**EAST GOSHEN TOWNSHIP
PLANNING COMMISSION
Meeting Agenda
Tuesday, July 30, 2024
7:00 PM**

Date: 7-26-2024
To: Planning Commission
From: Duane J. Brady Sr., East Goshen Township Zoning Officer
Re: **1010 Hershey Mill Road / Millstone Meadows
Preliminary/Final Subdivision and Land Development
Residential Open Space Development/Third Submission Letter**

The Township Fire Marshal has reviewed the Revised Subdivision Plans dated June 7, 2024, for the creation of a new 14 Lot Residential Open Space Subdivision/Land Development and has the following recommendations and comments:

"MILLSTONE MEADOWS"
 FINAL PLAN
 OPEN SPACE MANAGEMENT PLAN

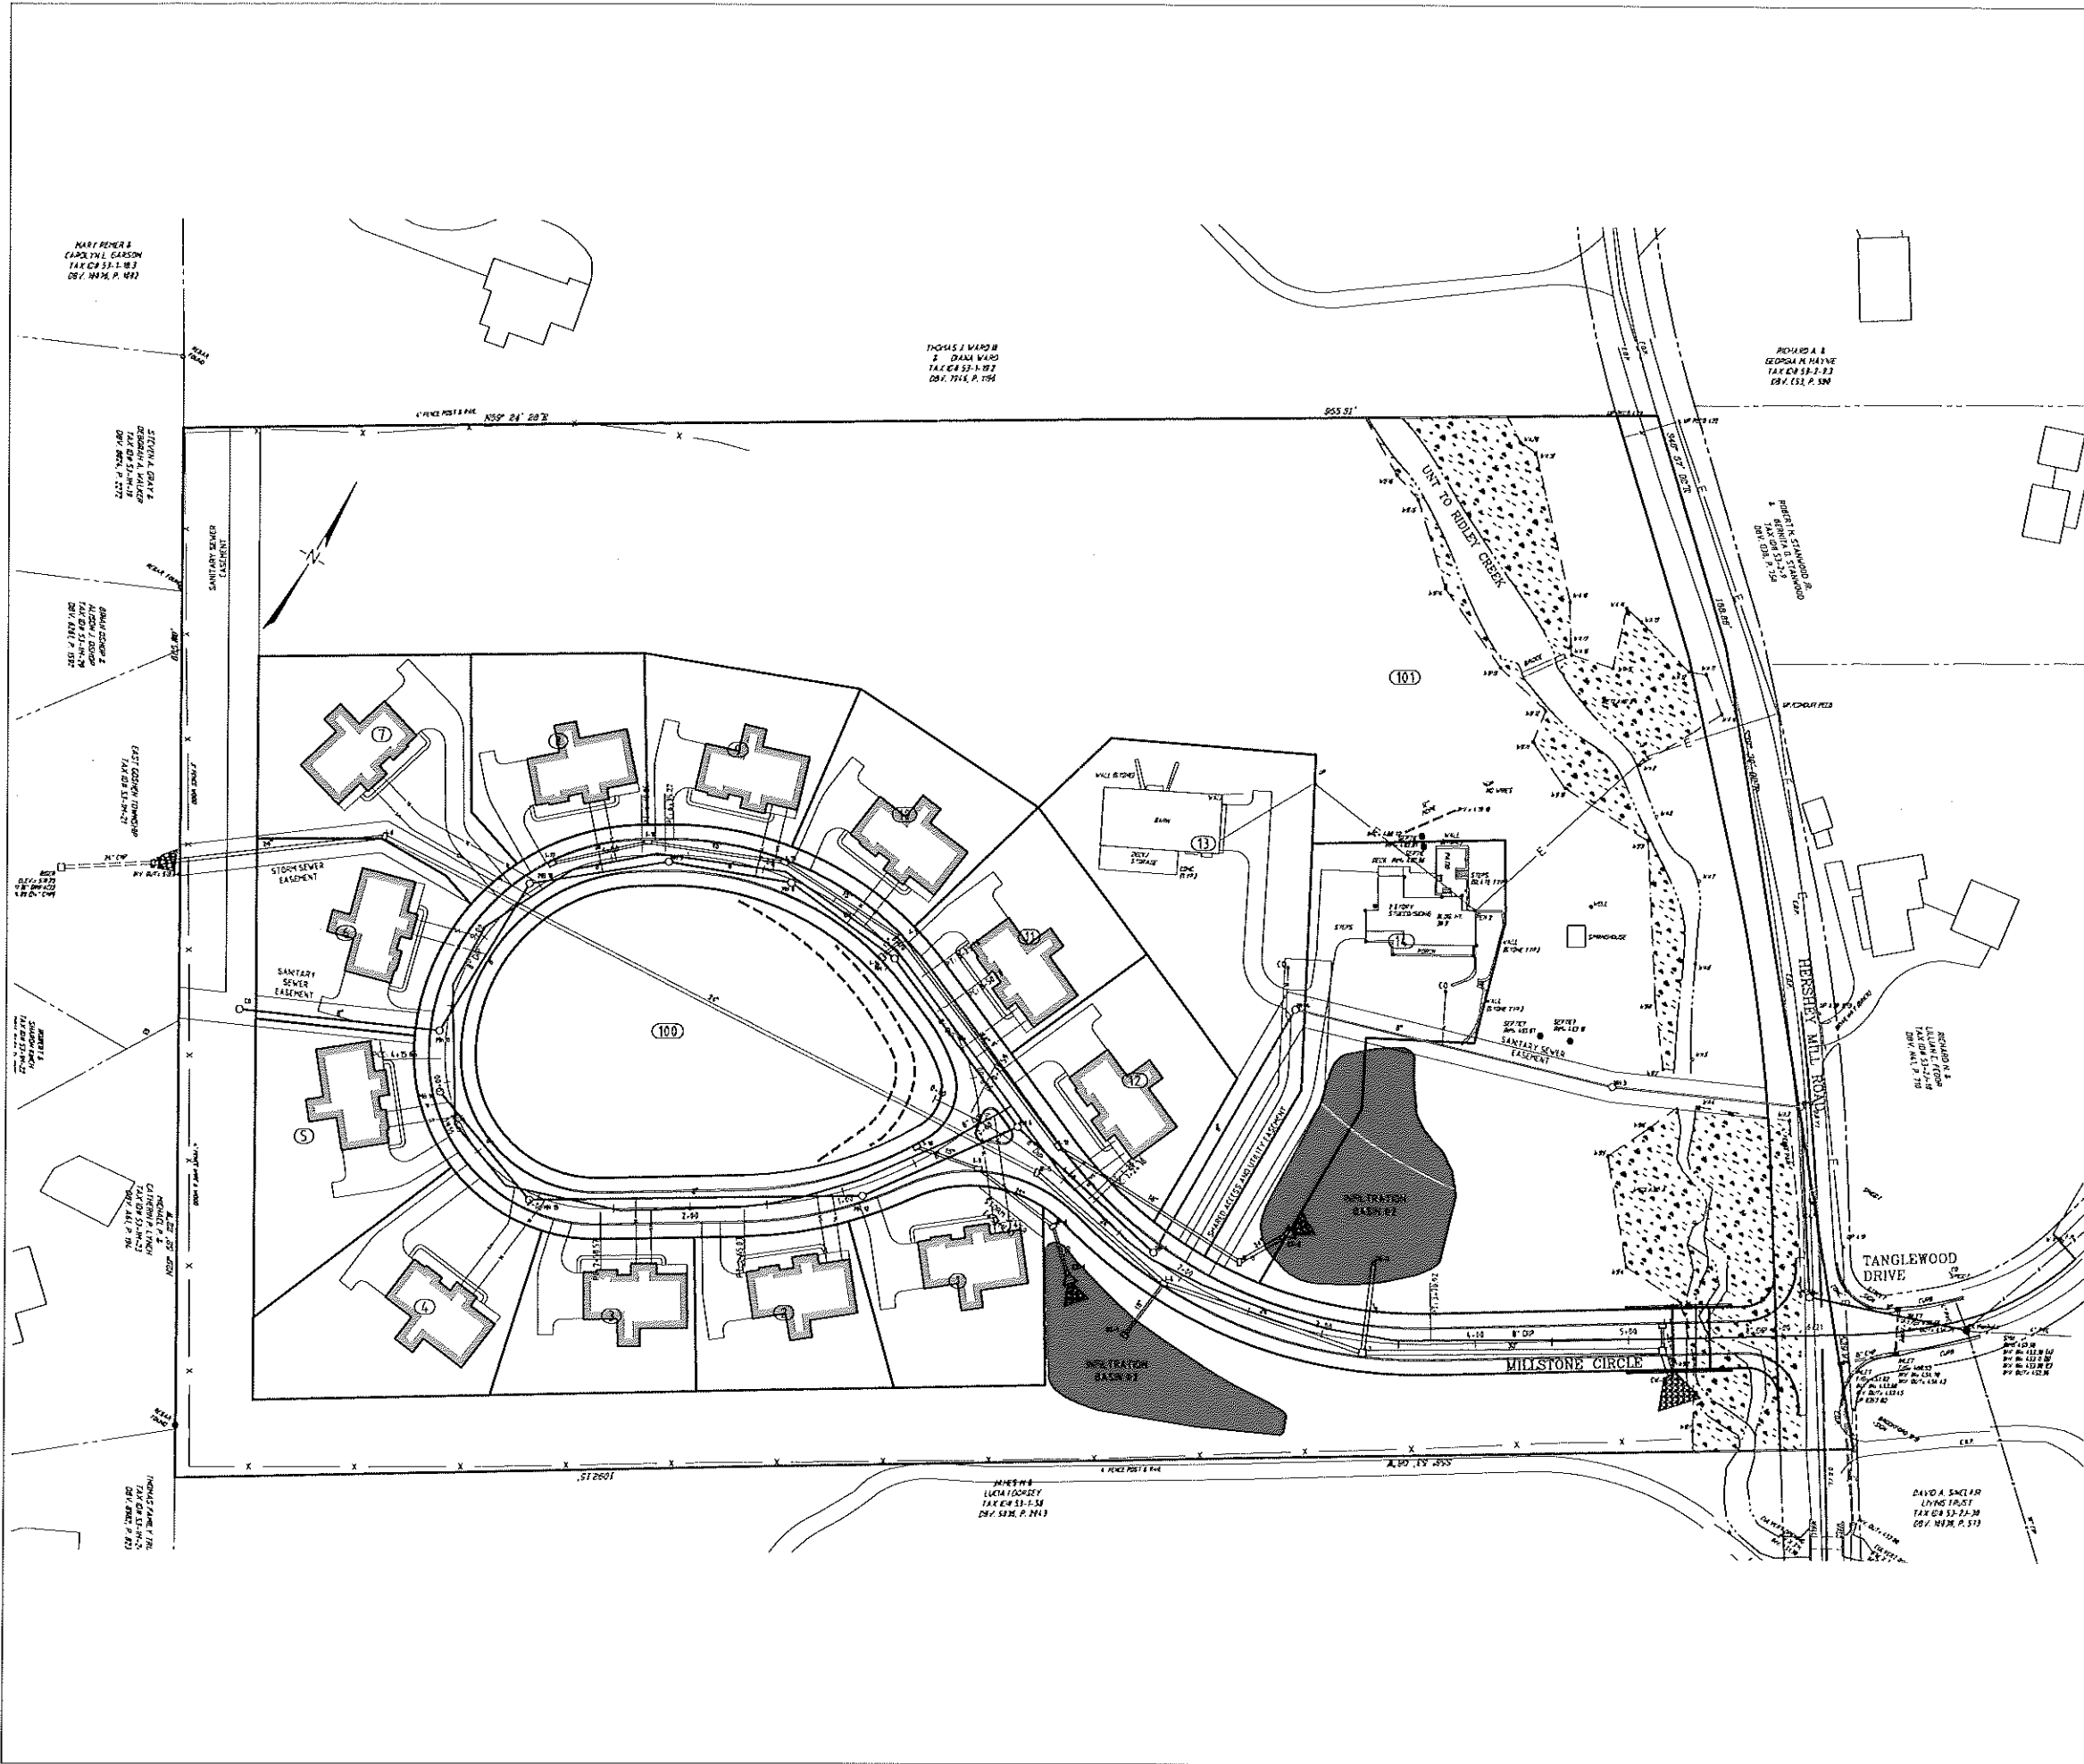
84. The Open Space Management provide no notes regarding maintenance.

Outstanding. Open Space notes #4 & #5 on Sheet 4 are unclear and seem to incorrectly reference the wrong parcel numbers. This discrepancy shall be corrected. The maintenance notes provided with the landscape details are specific to the installation of new lawns and plant material. They are not specific to the maintenance of natural areas that may involve re-forestation/landscape restoration. Notes along with a maintenance program similar to those provided on Sheet 17 for the riparian buffer management plan shall be provided to assist the HOA as guidelines for the life maintenance of these areas. See §240-36.E.(b).

Resolved. Notes regarding the maintenance of natural areas and re-forestation have been added to the Open Space plans on Sheet 4.

"MILLSTONE MEADOWS"
FINAL PLAN
LANDSCAPING PLAN

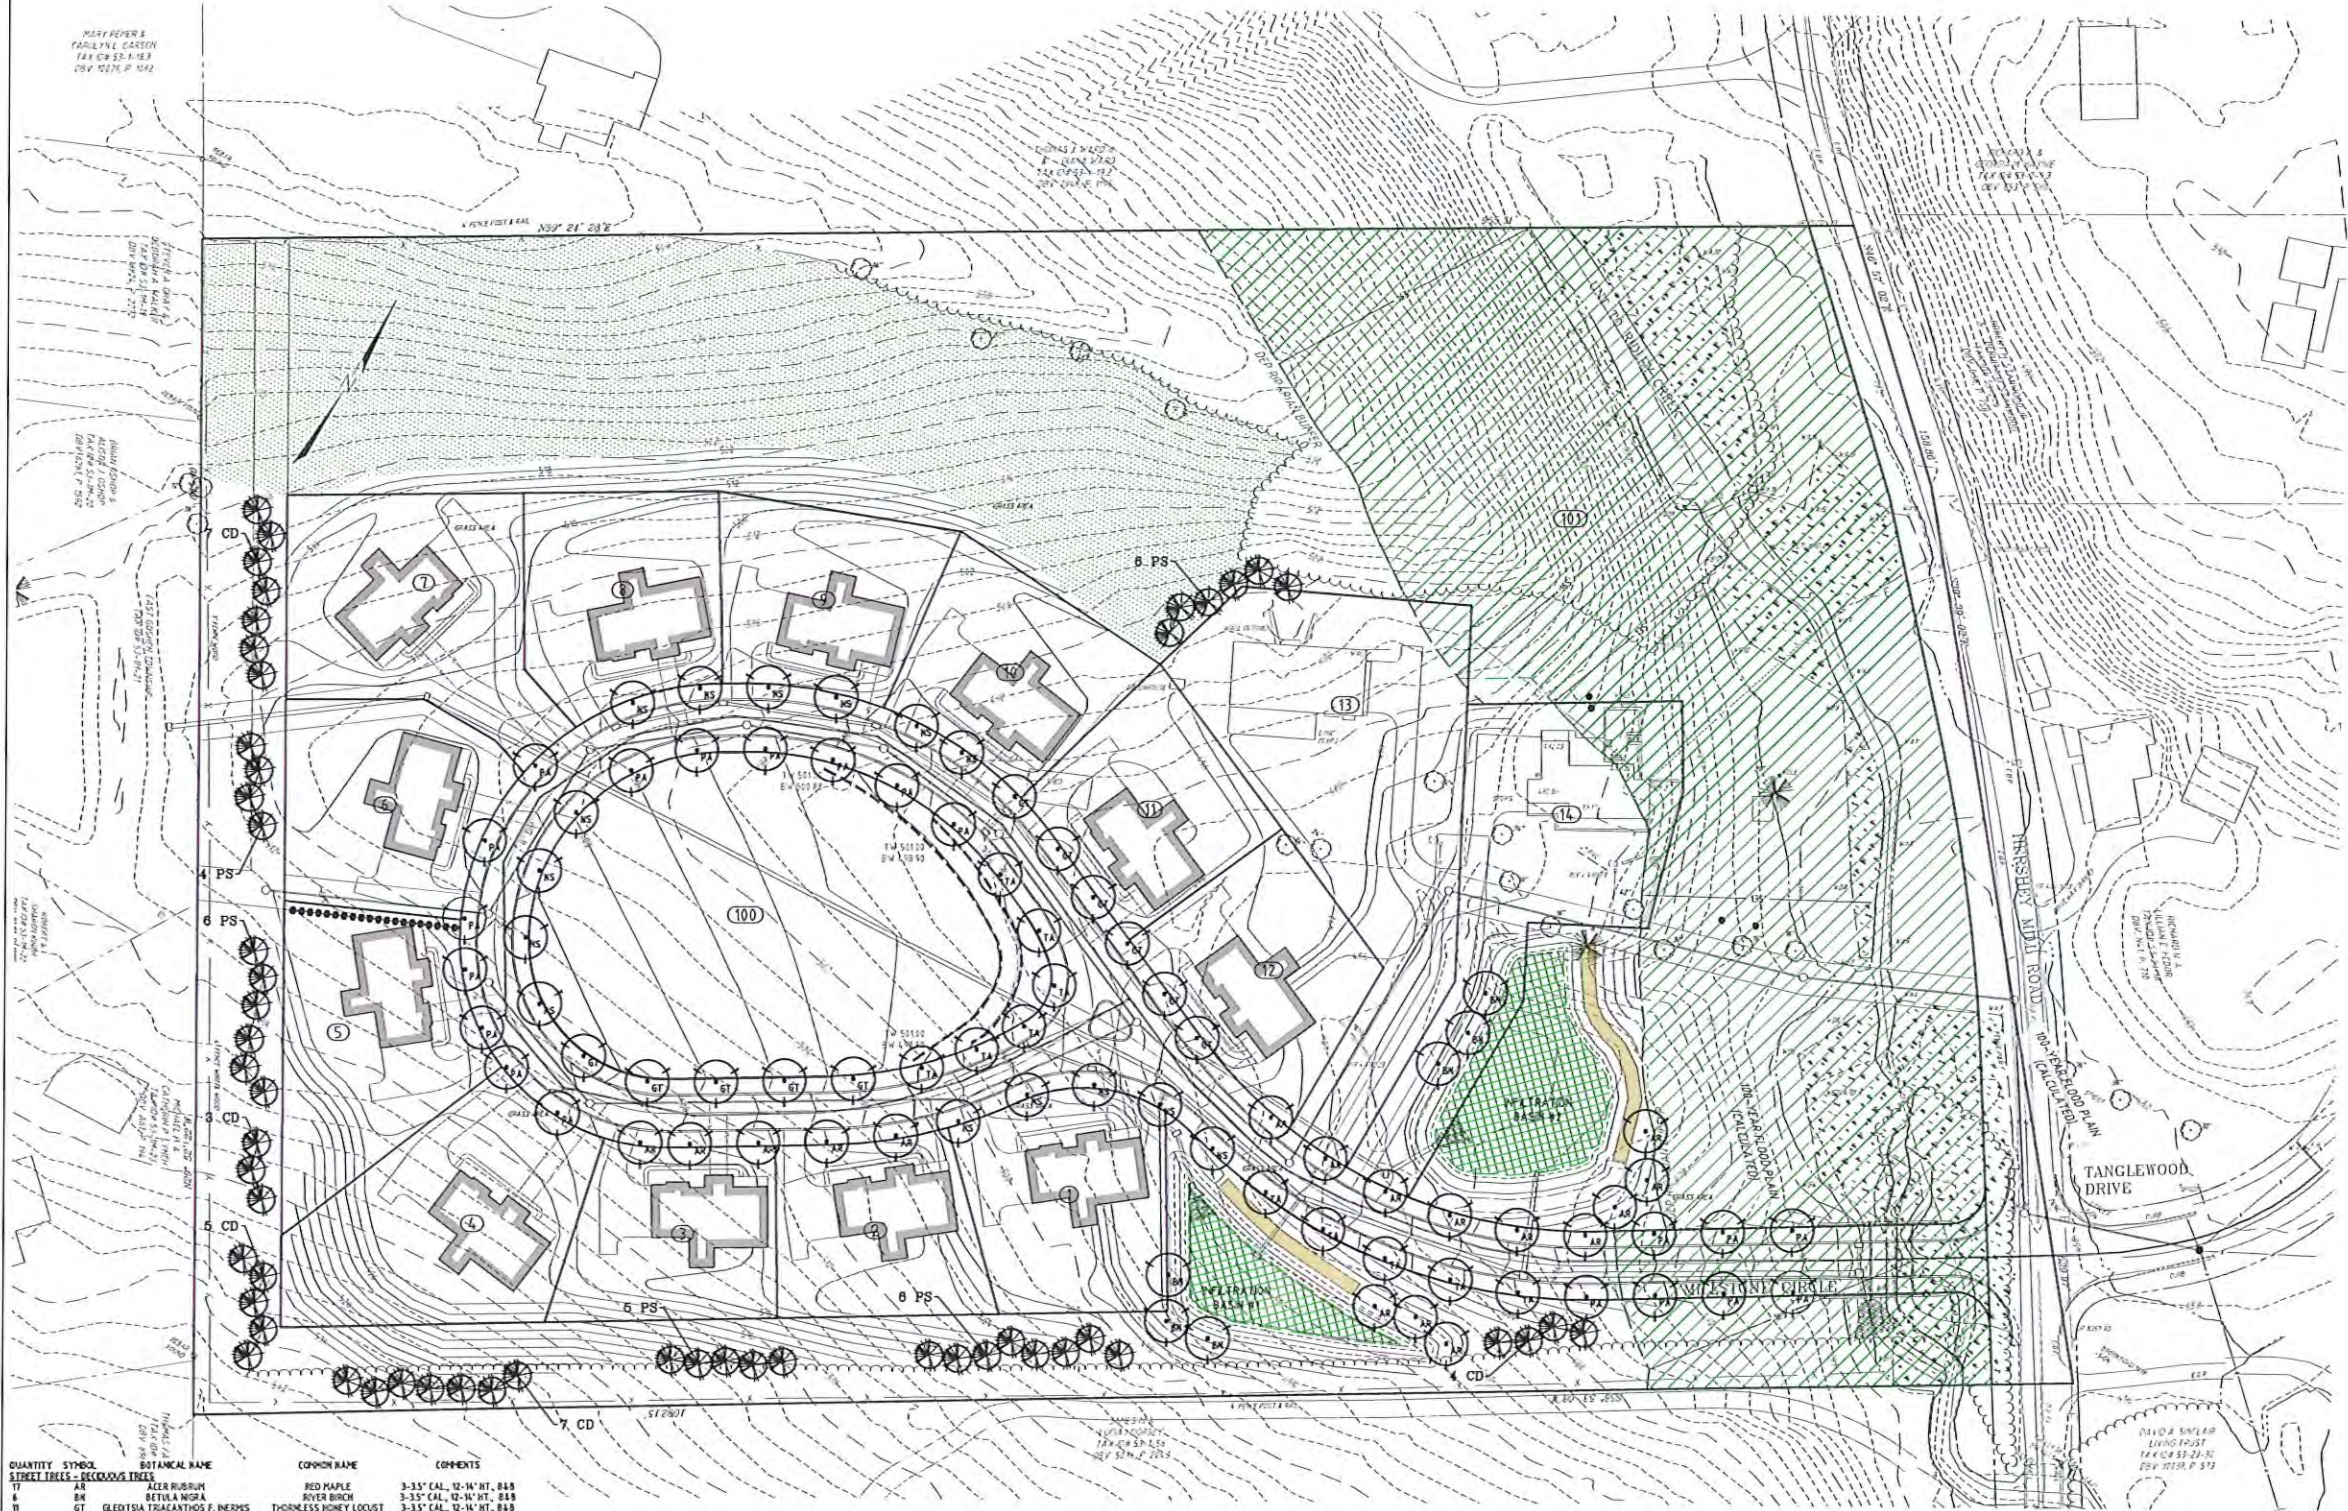
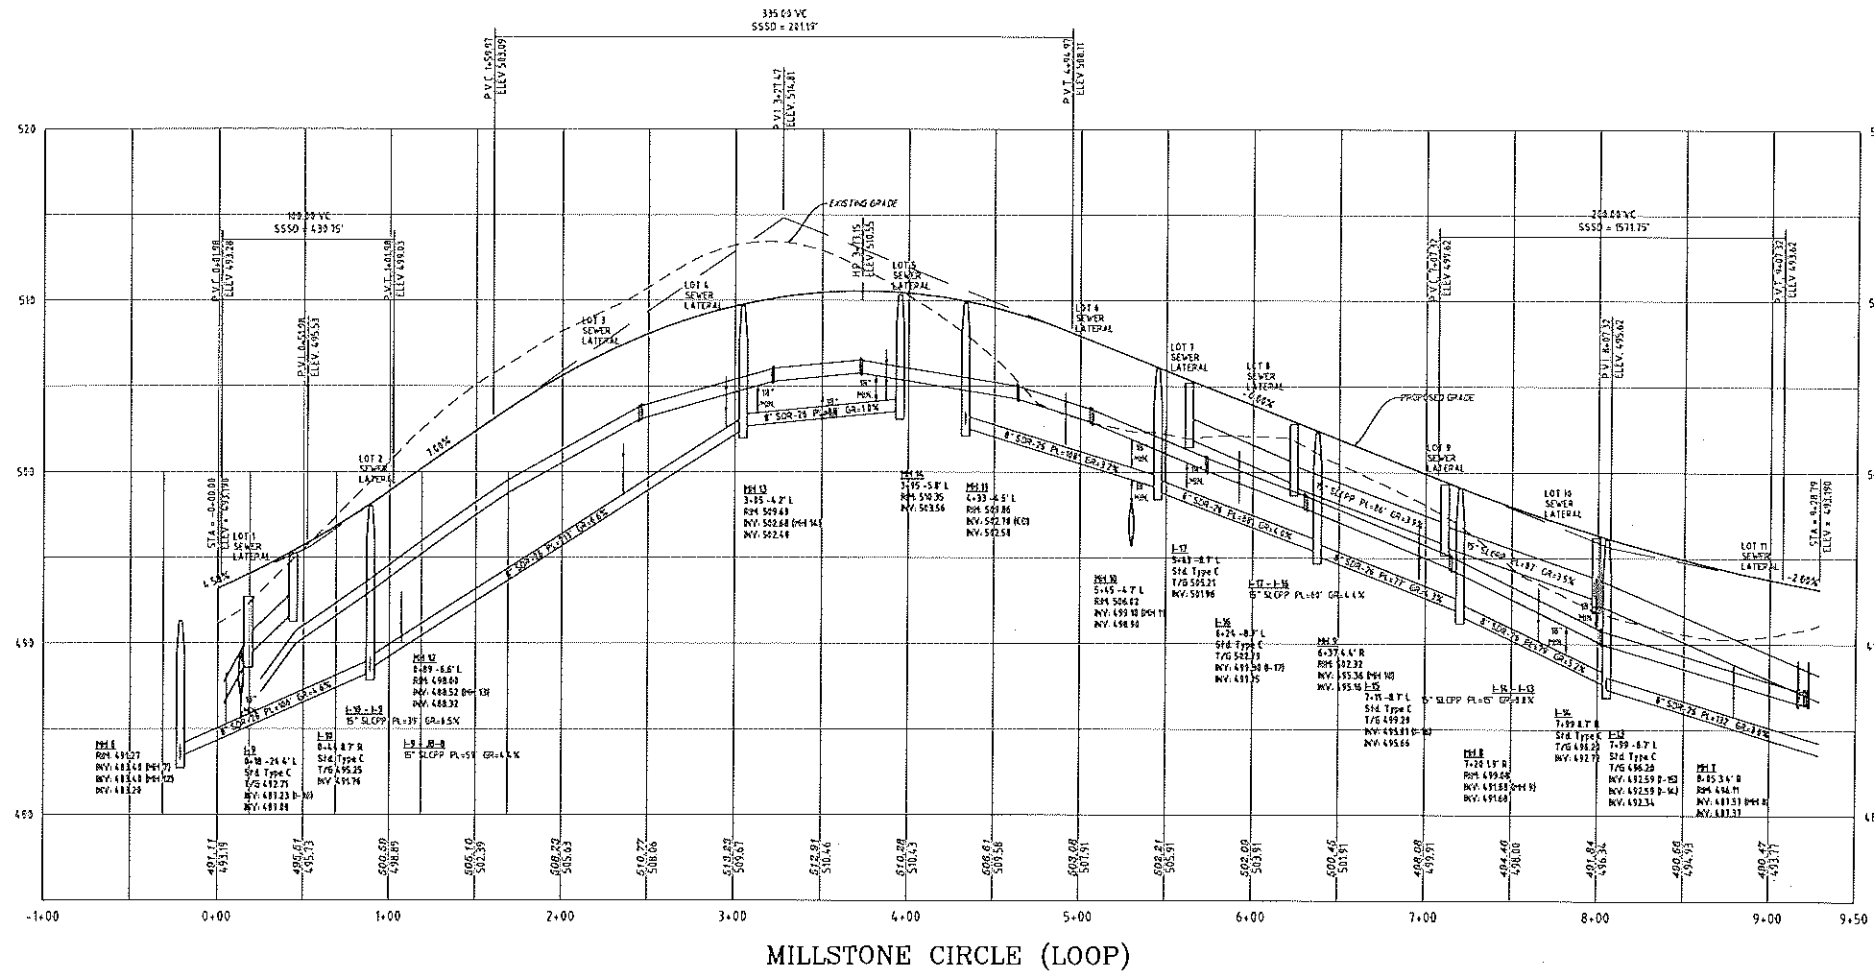
76. All buffer yards shall include a completely planted visual barrier or landscape screen. Such visual barrier shall be fully attainable within a three-year period. (§205-60.B)

Further, where the existing tree masses do not fully screen the area or where there are no existing tree masses, plantings shall be added to complete the visual barrier within the prescribed time period. (§205-60.B(2))

Groupings of evergreens trees have been provided; however, they do not provide a completed planted visual barrier. Additional plant material shall be provided to meet this requirement or clarity regarding existing vegetation/visual buffers provided for all property boundaries.

Resolved. The proposed plan and landscape plantings were presented to the Conservancy Board and were considered acceptable, and the Board provided their recommendation for approval.
